TRANSMITTAL DOCUMENT FOR THE MAY 6, 2020 PLANNING BOARD MEETING

Town of Bar Harbor Planning Department Staff Report

Compliance Review & Public Hearing Site Plan SP-2020-02 - Bar Harbor Oceanside KOA

Planning Board site visit notes — The Farm, LLC subdivision — November 21, 2019

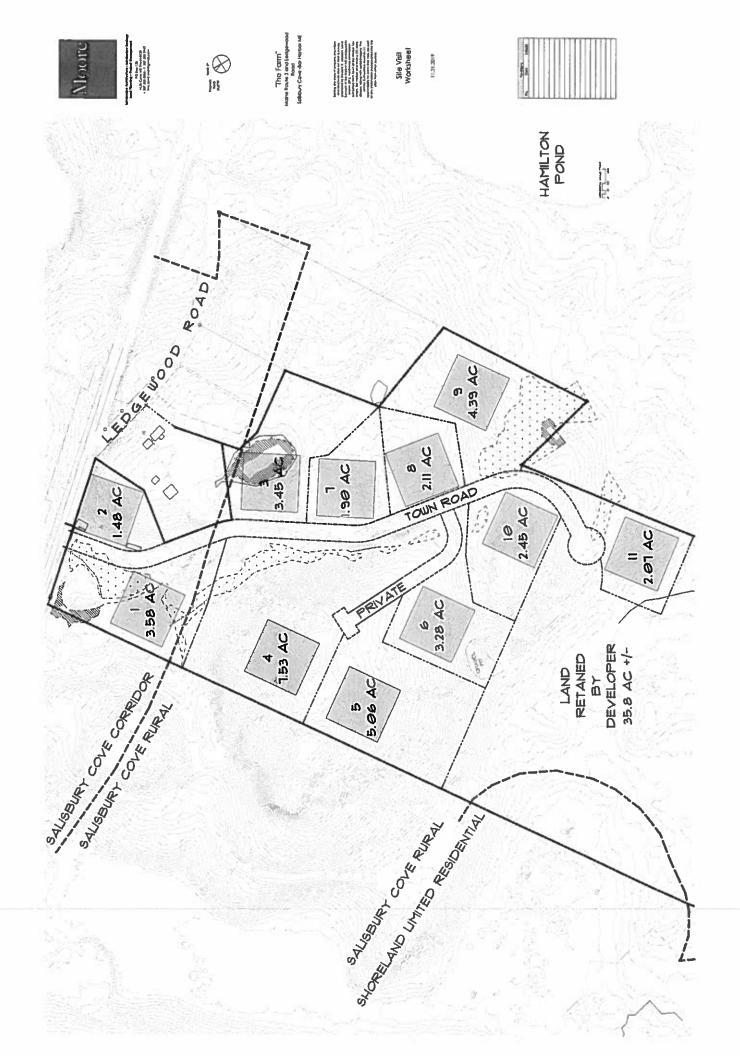
There was a question about this property and its relation to the Northeast Creek watershed. Mr. Moore showed approximately where Northeast Creek is in relation to the property (off of the site plan) and where Fresh Meadow is as well. He said there was a lot of human activity in and out of Fresh Meadow over the years.

There was a question about water service. Mr. Moore said all houses will be on private wells. He spoke again about the location of the fire pond on Lot 7, and why it works both from topographic and safety (halfway between both ends of town road) perspectives.

There was more discussion about the Northeast Creek watershed. Mr. Moore noted that because of the scope of the project, and because there is more than one acre of impervious surface proposed, the application will have to go to the Maine Department of Environmental Protection for a stormwater permit. Mr. Moore said ditches along the town road will drain into vegetated buffers.

A resident with property on the southeastern side of the proposed subdivision, in proximity to Lot 9, asked a question about the septic system on that lot in relation to how close it is to Hamilton Pond, which he noted then drains in to Northeast Creek.
